# Road Safety Audit Review

Ferry Road, Charlotte

July 23, 2020

Vermont Agency of Transportation  
Operations & Safety Bureau

Proposed Warning Signs Layout

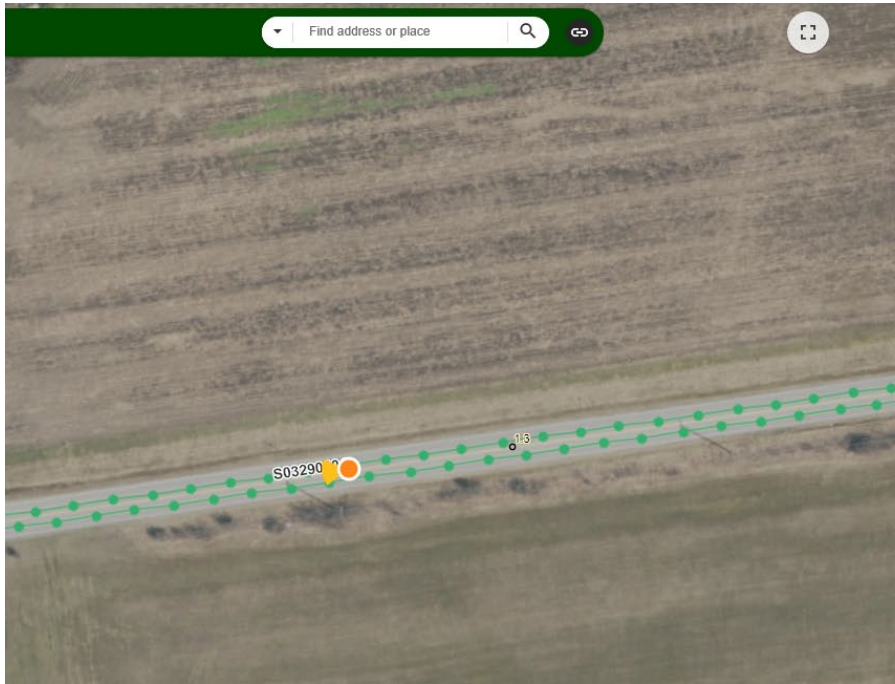
Remove the existing intersection sign for westbound Lake Rd intersection.

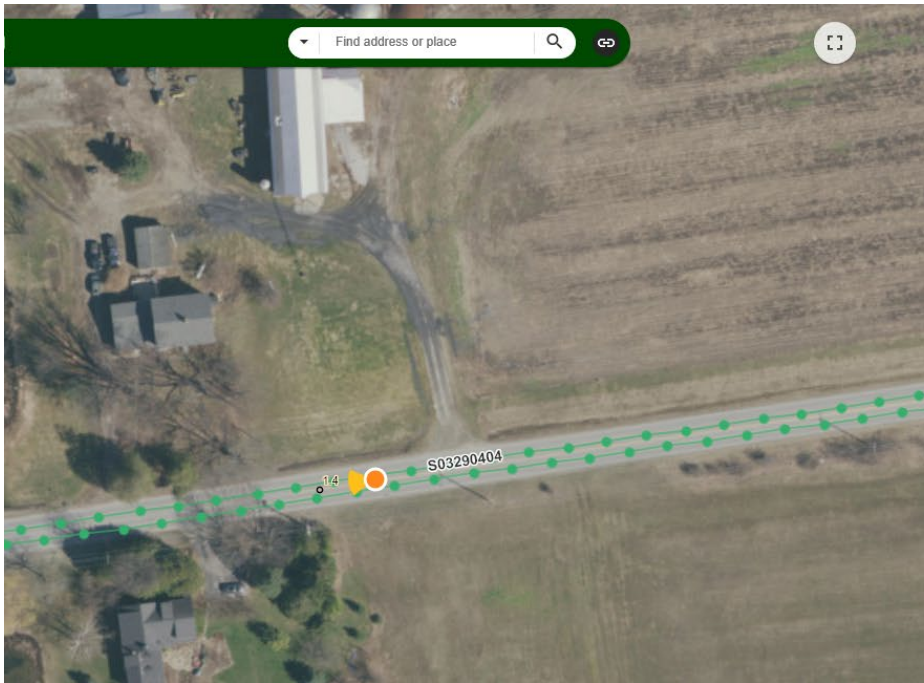
Install an intersection sign (W2-1) with a Lake Rd street name plaque (W16-8P) about 300 ft east of Lake Rd.

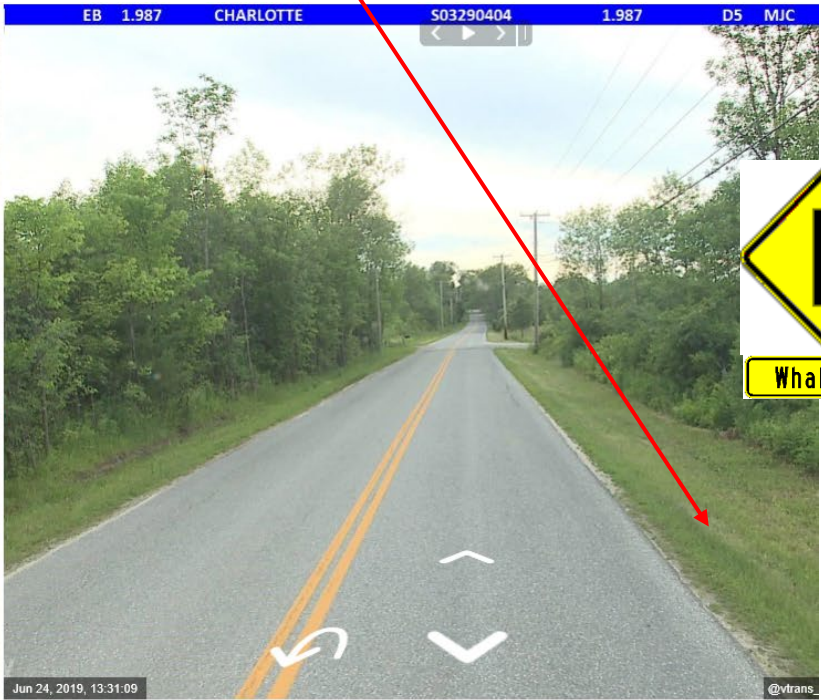
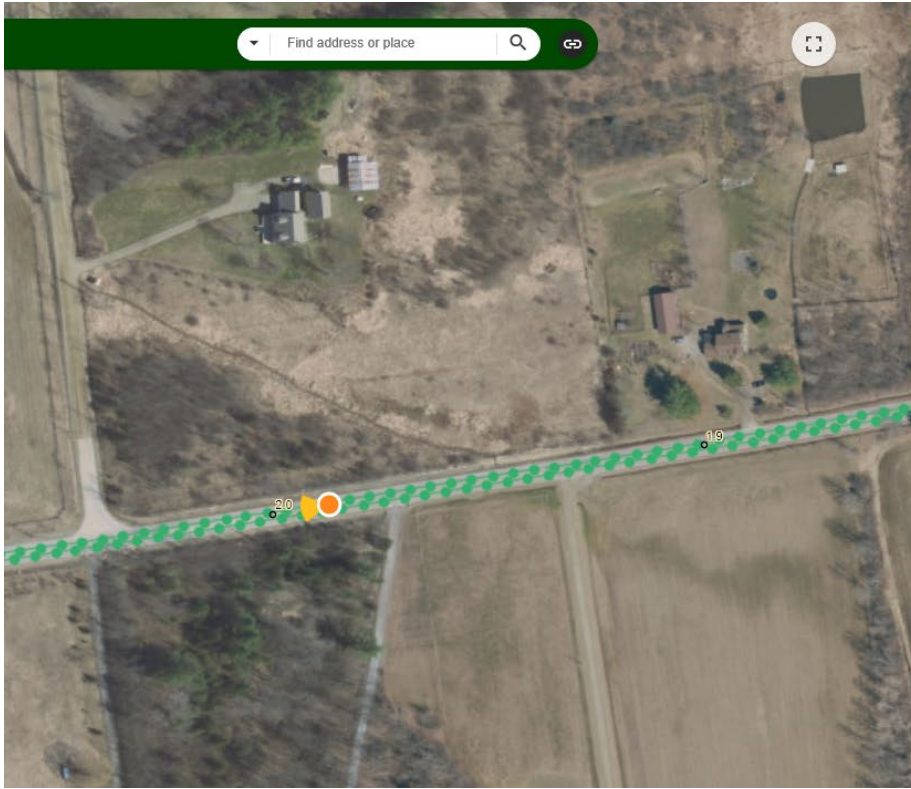
Install a side road intersection sign (W2-2) with a Whalley Rd street name plaque (W16-8P) 300 ft east of Whalley Rd.

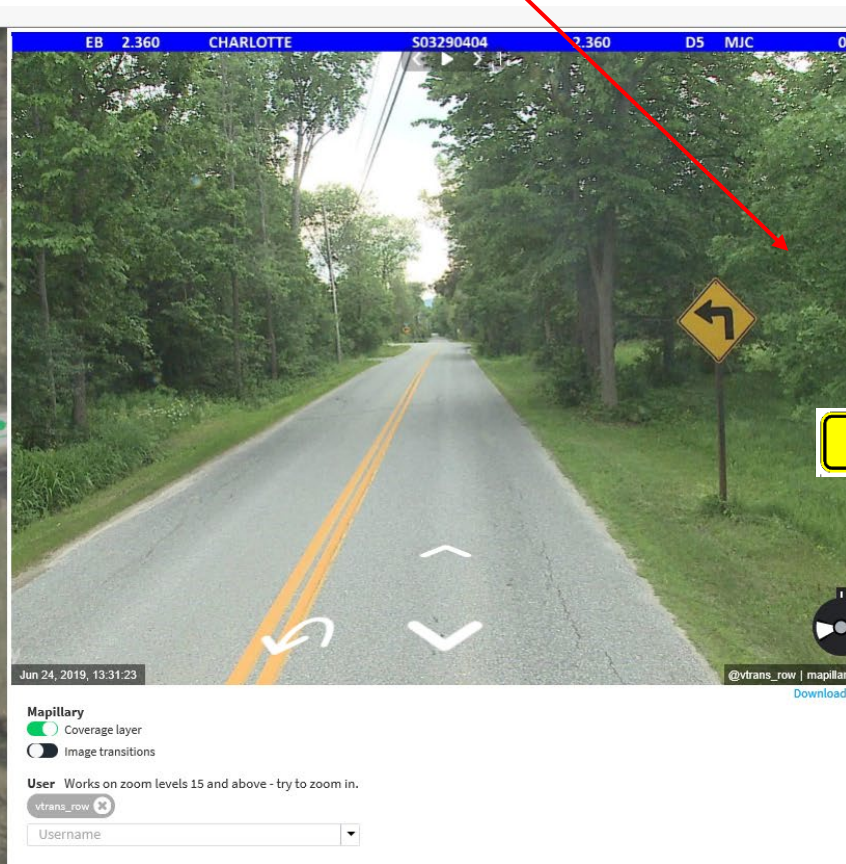
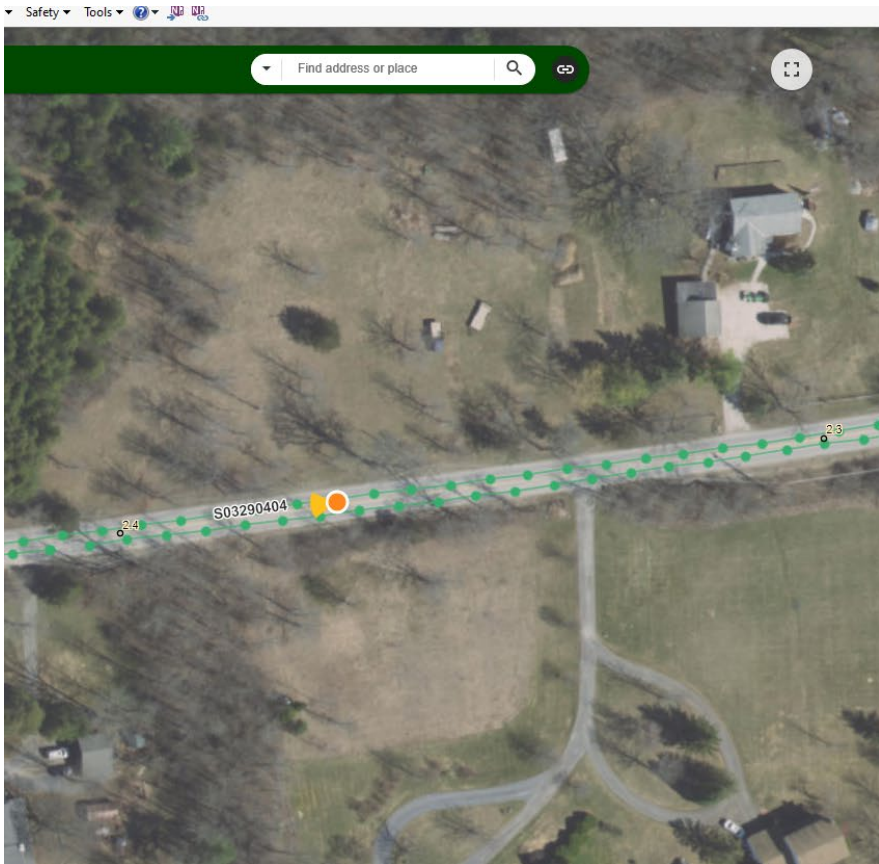
Replace the turn sign with a modified turn sign with a side road up and a 15 mph advisory speed plaque (13-1P), and a Wings Point Rd street name plaque (W16-8P).

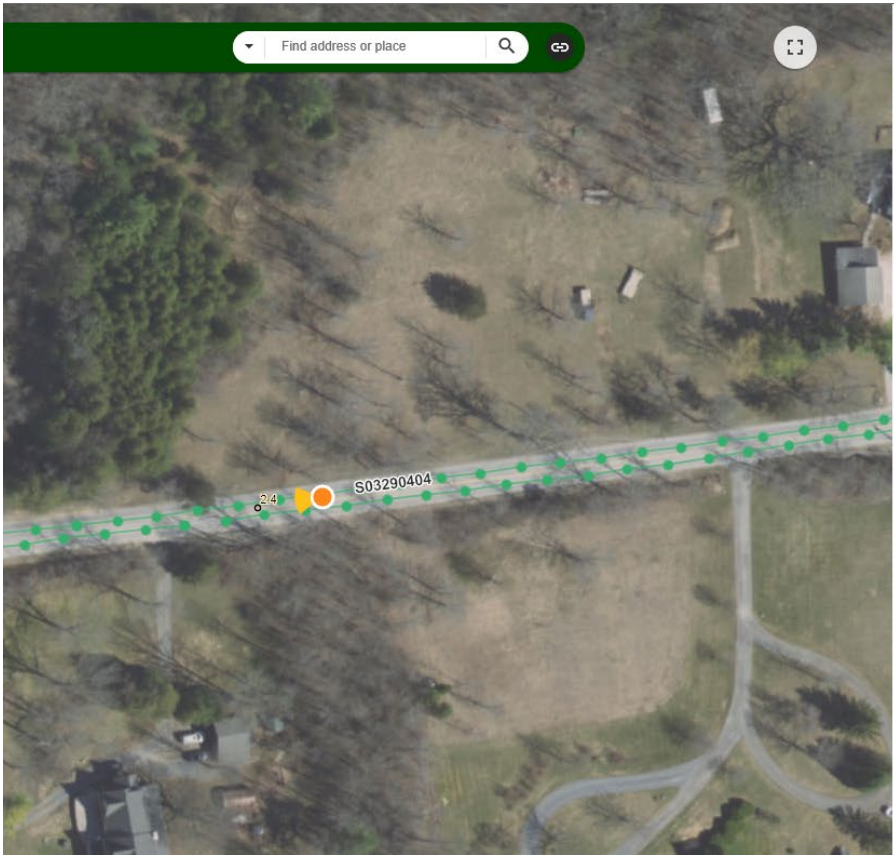
Install a Ferry destination sign (VD1-1) on two posts here.

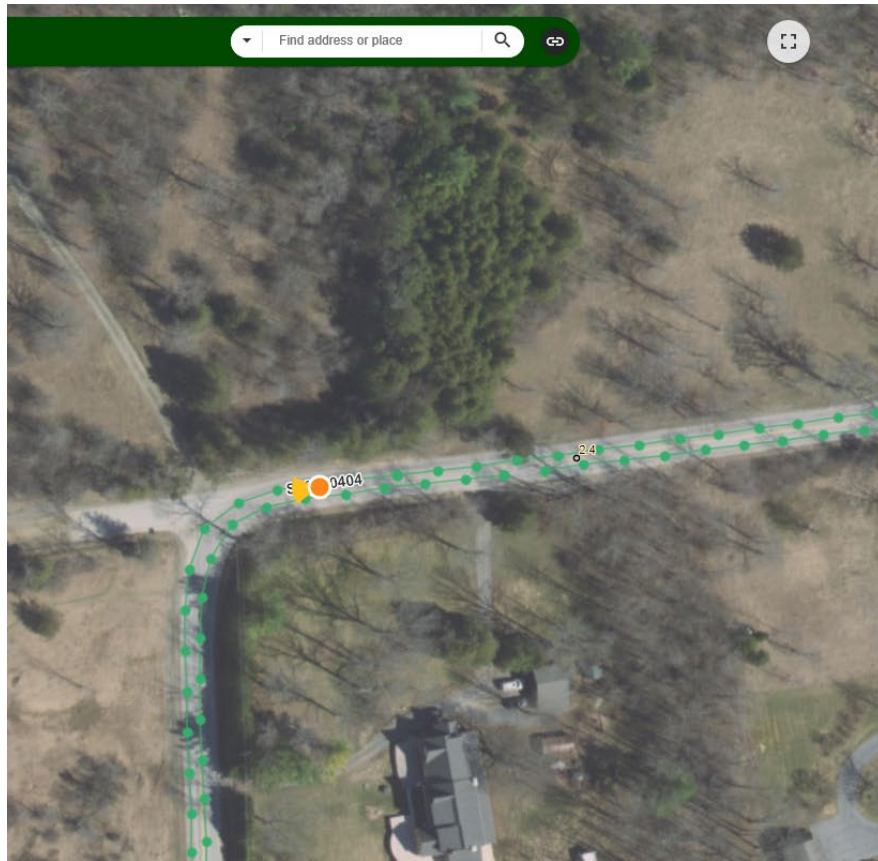
At Wings Point Rd, remove the large arrow and the small yellow ferry sign.

Install a new large arrow (W1-6) here.

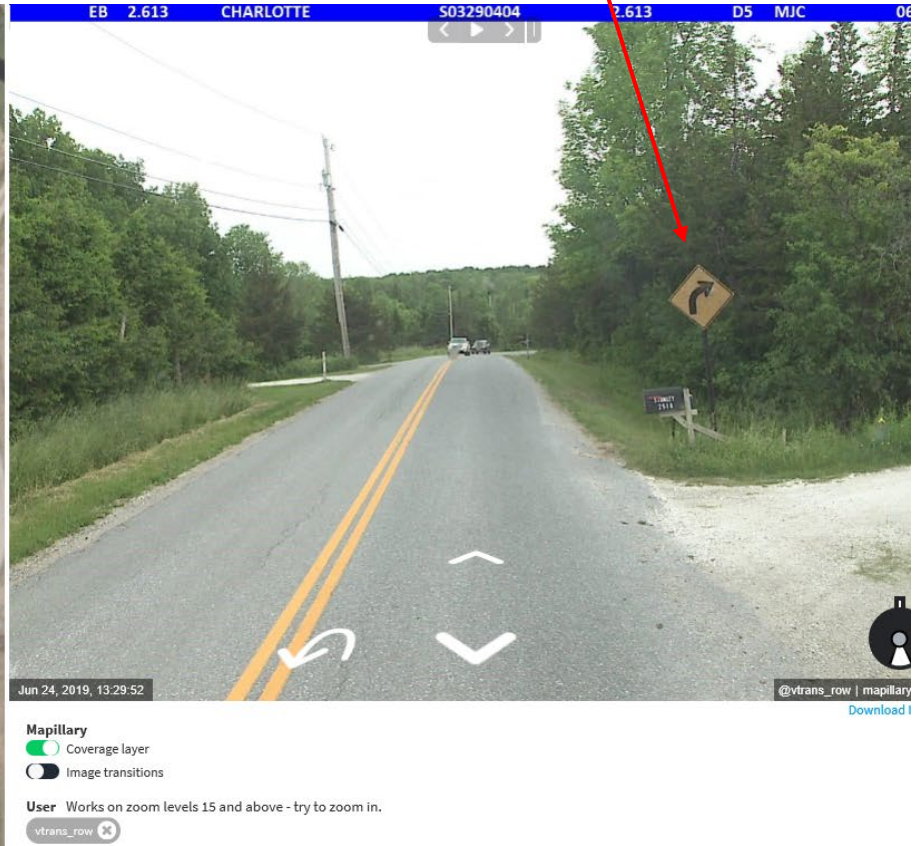
Replace the existing curve sign (W1-2) by mailbox #2518.

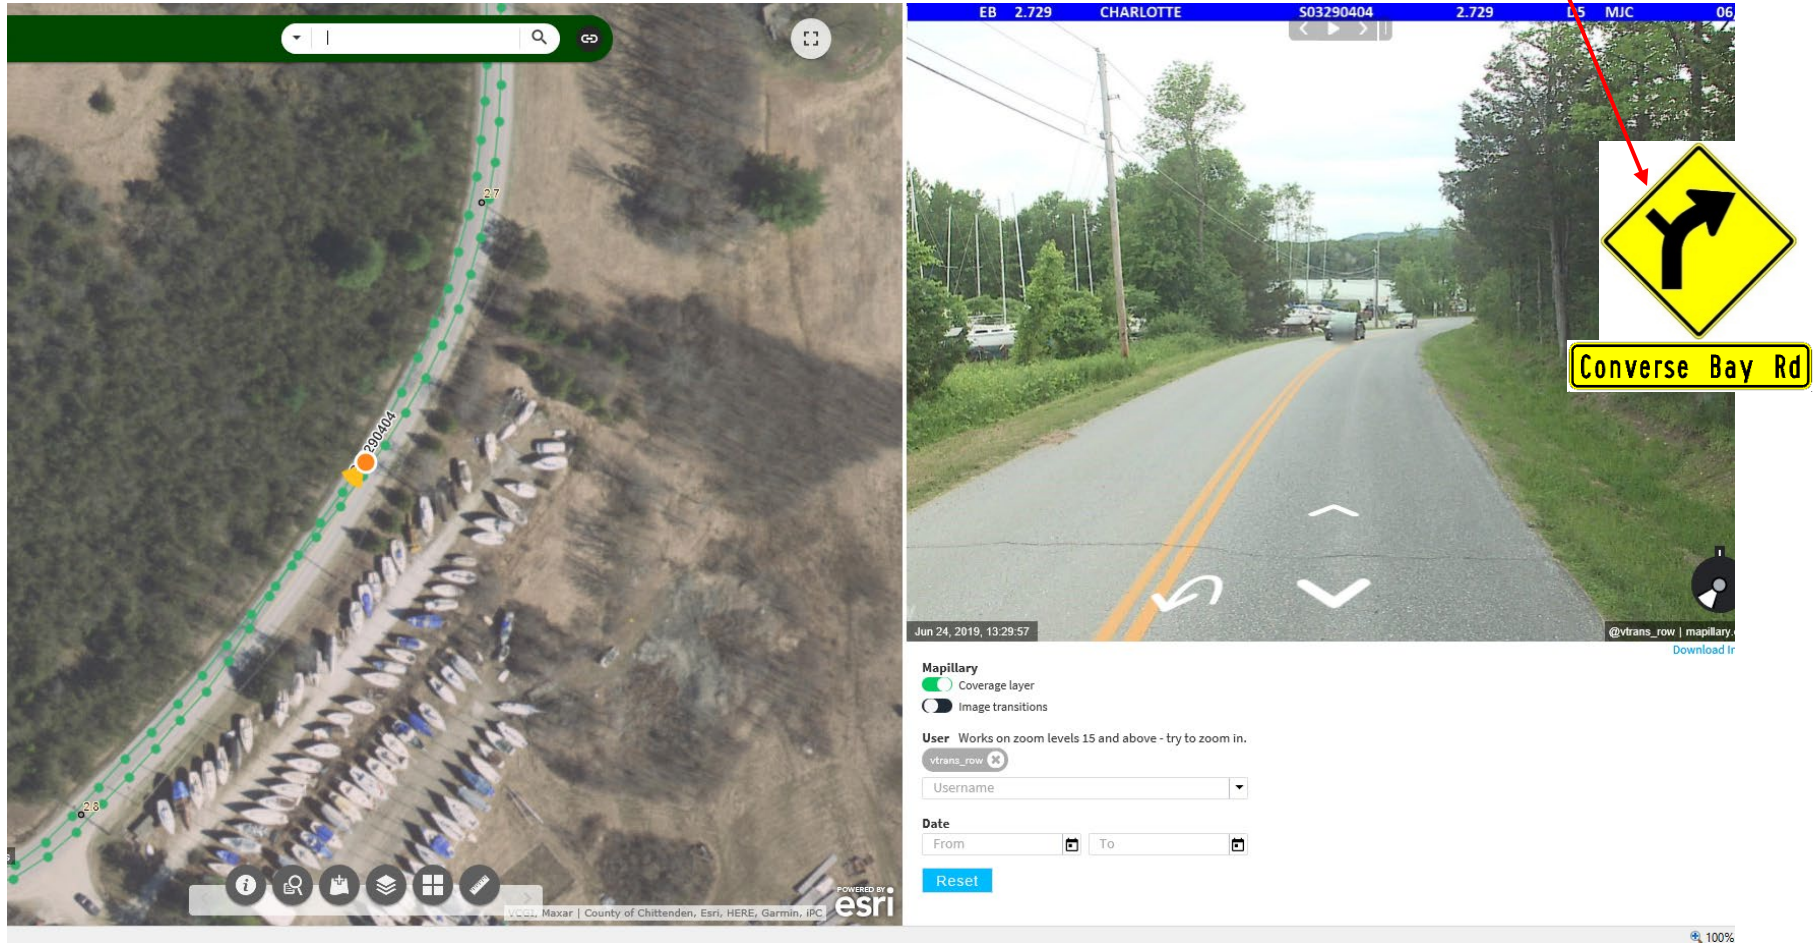
New curve sign with side road (W1-10) and Converse Bay Rd street name plaque (W16-8P). Approximately 150 east of new Ferry Rd destination sign or if chose not to install the Ferry Rd destination sign, 200 ft east of Converse Bay Rd. Install on two posts.

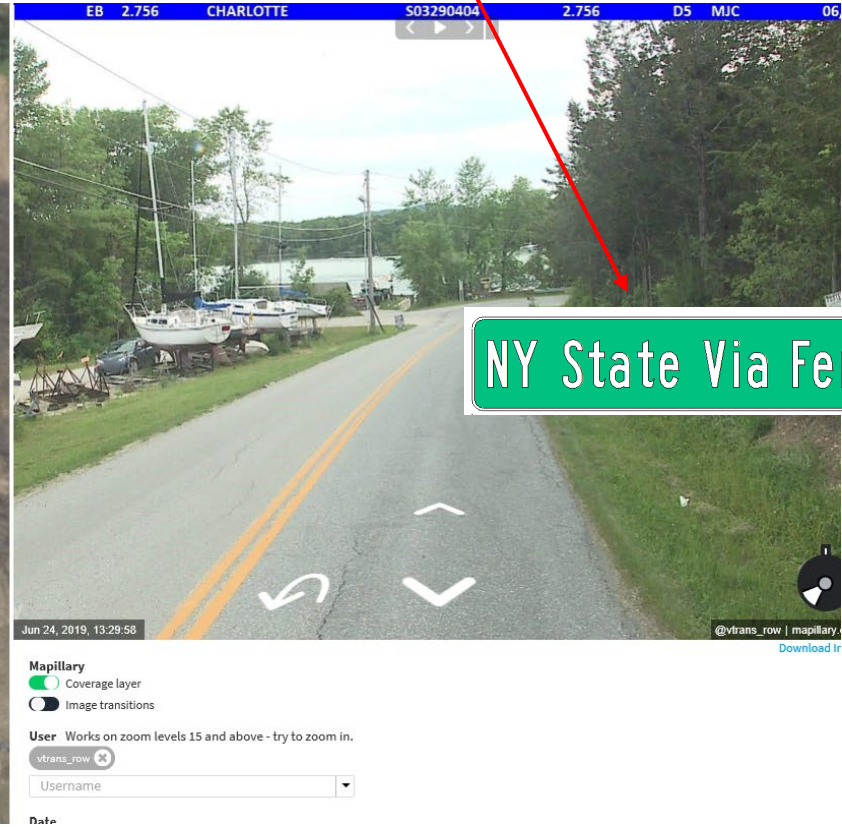
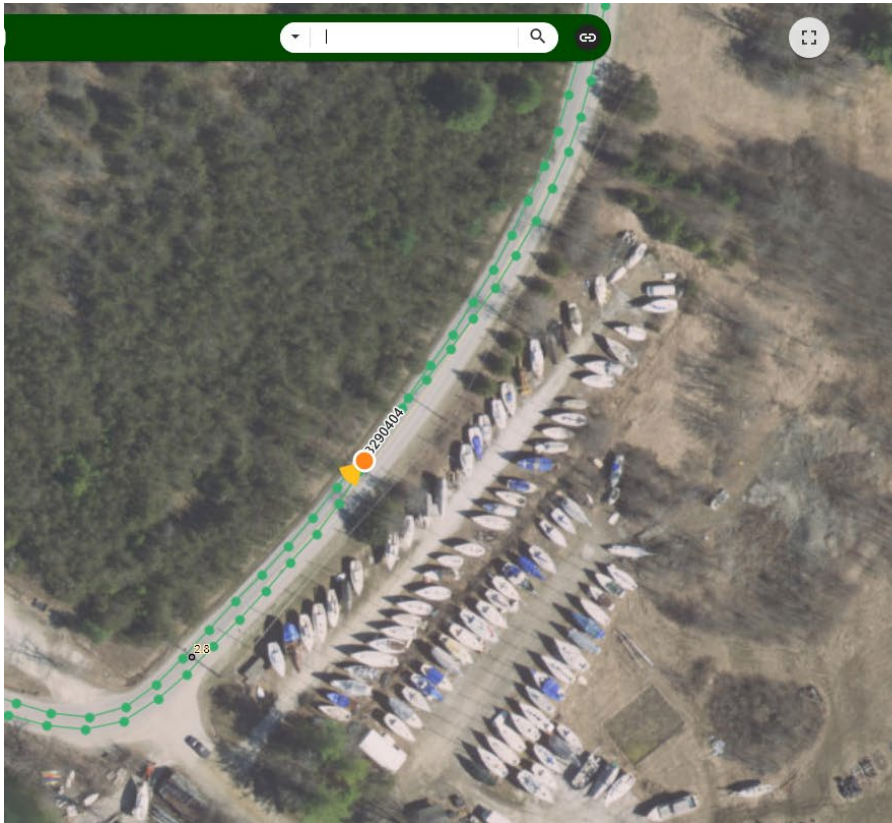
New Ferry destination sign (VD1-1). Approximately 200 ft east of Converse Bay Rd. Install on two posts.

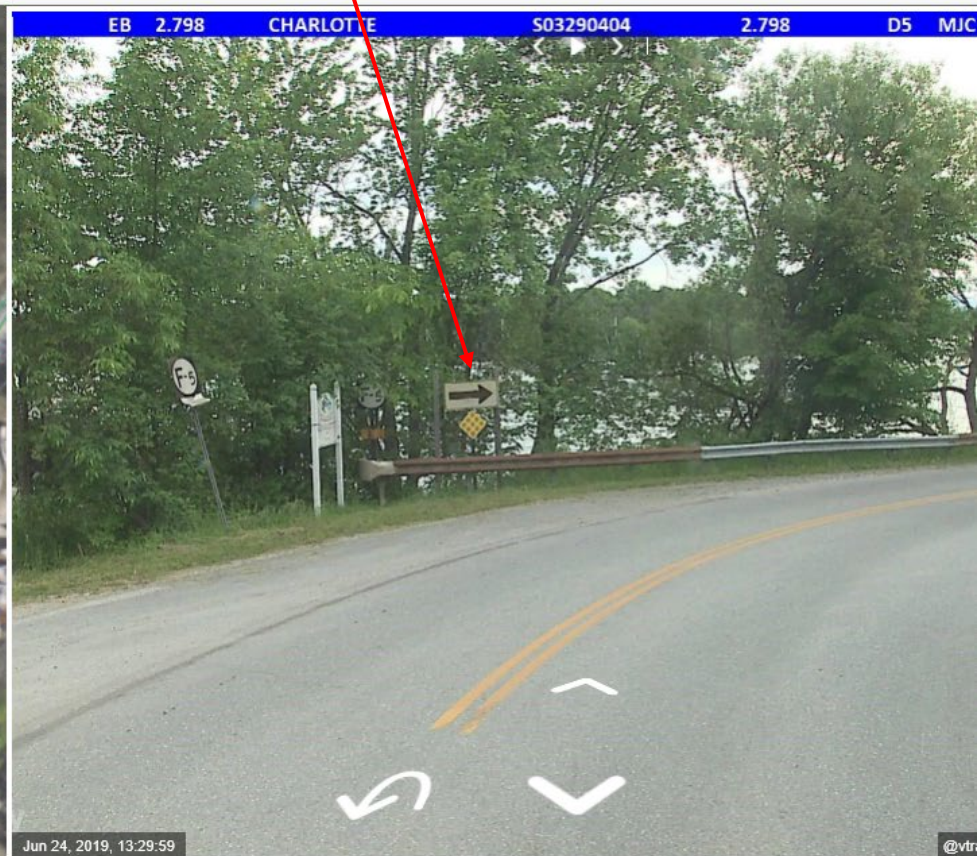
Remove the diamond object marker. Replace the existing large arrow with a new large arrow (W1-6). Install on two posts.
